**CVL Network – Network Code Condition G1 Network Change Proposal:
Llandaff Line speed change**

Proposed Scheme Title	Proposed Scheme Detail	Appendix*
Llandaff Line speed change	Implementation of change from Temporary Speed Restriction (TSR) to Permanent Speed Restriction (PSR) on the Up & Dn Llandaff	Appendix A

Appendix A – Proposed Llandaff Line speed change TSR to PSR

Annex A1 – Proposed Amendments to the Existing Sectional Appendix

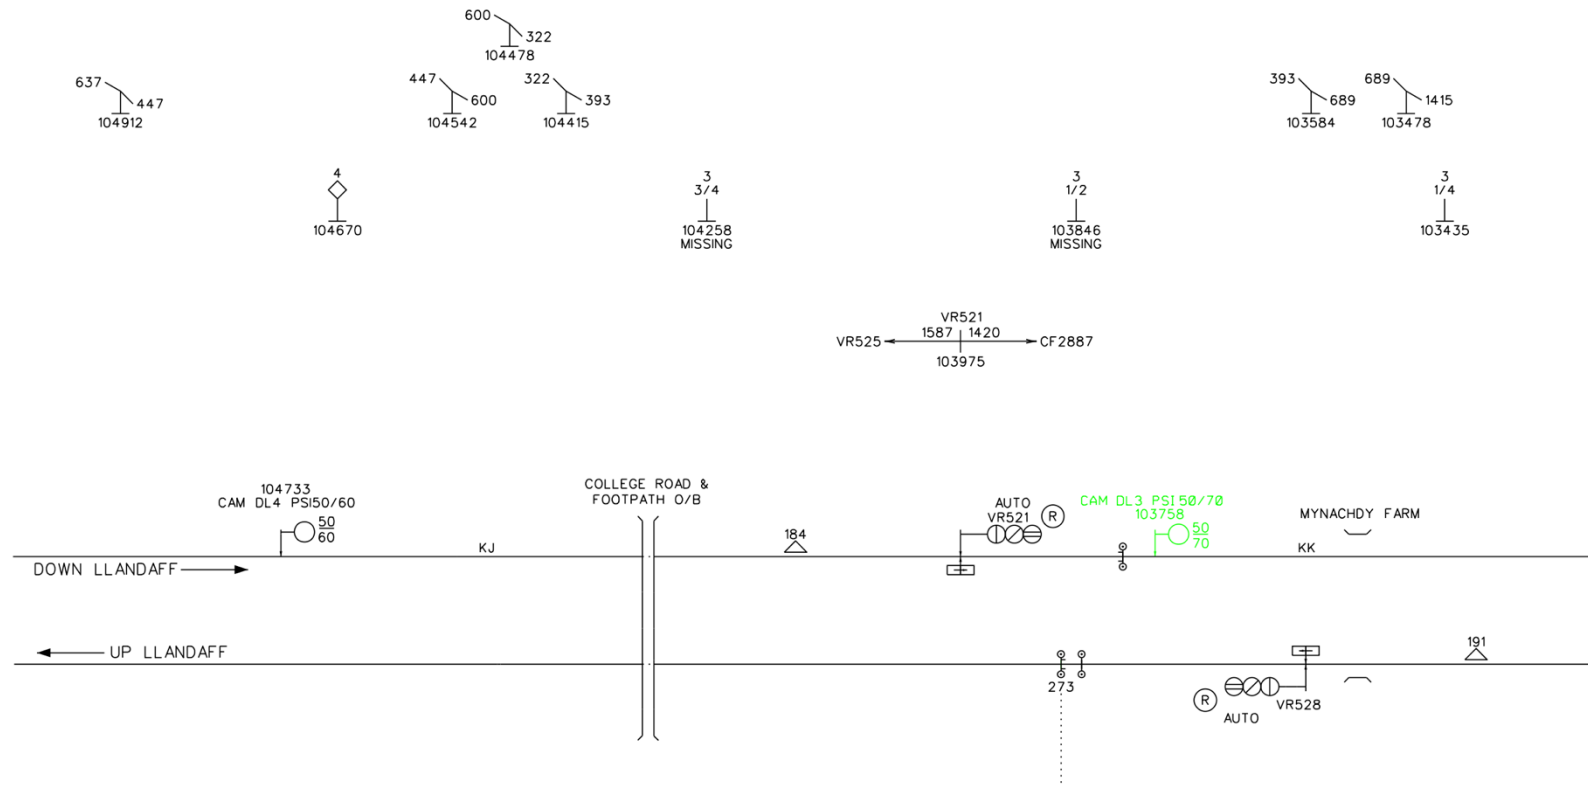
LOR	Seq.	Line of Route Description		ELR	Route	Last Updated
GW830	009	Merthyr Tydfil to Barry Island Via Cardiff Queen Street		CAM	Wales - TFW CVL	02/08/2025
Location		Mileage M Ch	Running lines & speed restrictions		Signalling & Remarks	
		4 27			<div>TCB Core Valley Lines Integrated RA8 Control Centre-TAM Wrkstn(VR) AC: CVLICC</div> <div>Permanently Earthed Section both lines 4m 19ch - 4m 33ch Axle counter area Non - SPT area DL - Down Llandaf UL - Up Llandaf Permanently Earthed Section both lines 3m 59ch - 3m 74ch UL and DL electrified</div> <div>Wales Rail Operating Centre (Valleys) (CF)</div> <div>SPT area Axle counter area</div> <div>Platforms - 124m (135 yards)</div> <div>GSM-R</div>	
		4 20 *				
		4 04 *				
		3 35 *				
		2 72				
Limit of electrification on DL		2 57				
Limit of electrification on UL						
CATHAYS		1 61				
		1 58 *				
		1 34 *				
		1 29 *

Annex A3 – Scheme plan extracts for information

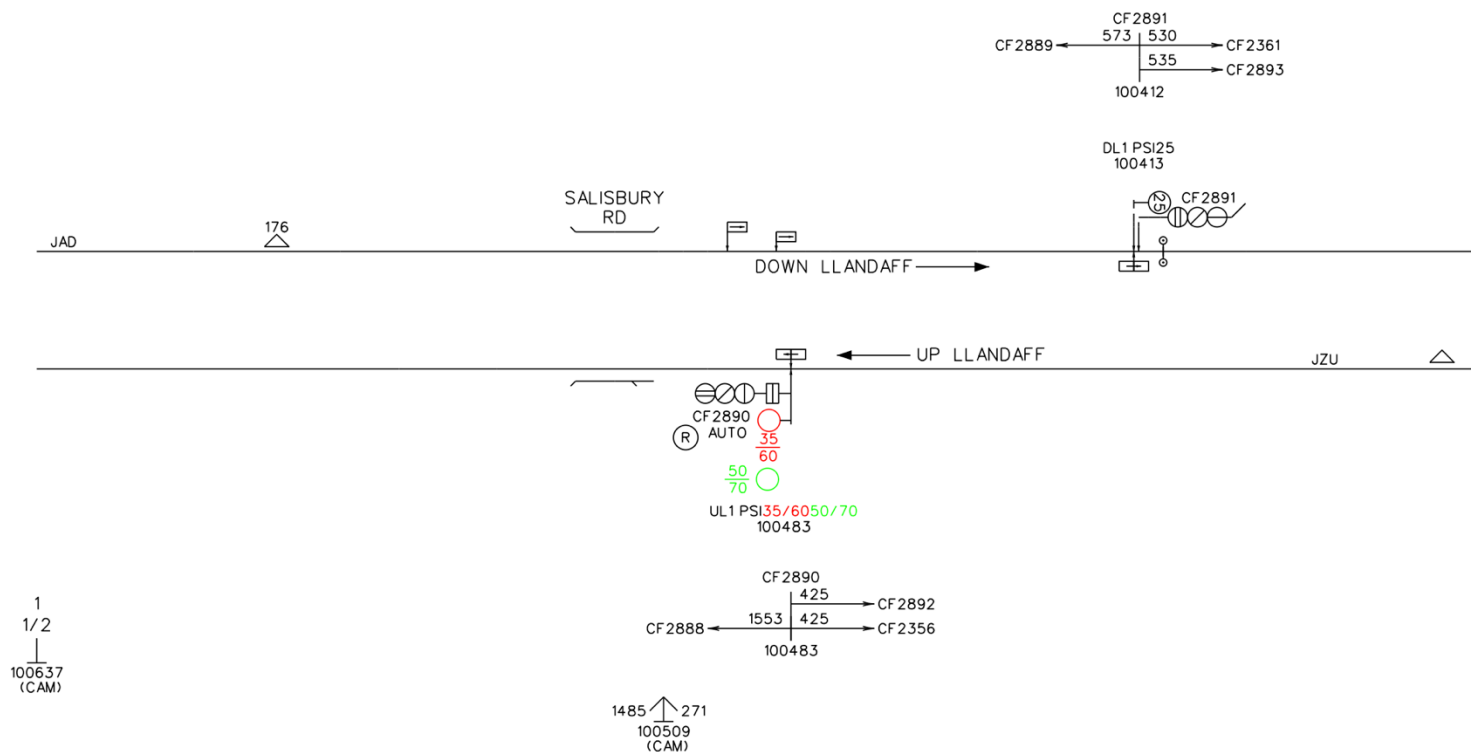
- Replacing the 50/70 speed sign mounted on CF2890 signal (1m 34ch) with 35/60 speed sign.
- Recovering CAM DL3 PSI 50/70 PSI at 103758 (3m 44ch), this will extend the 50/60 from CAM DL4 PSI50/60 at 104733 (4m 04ch).
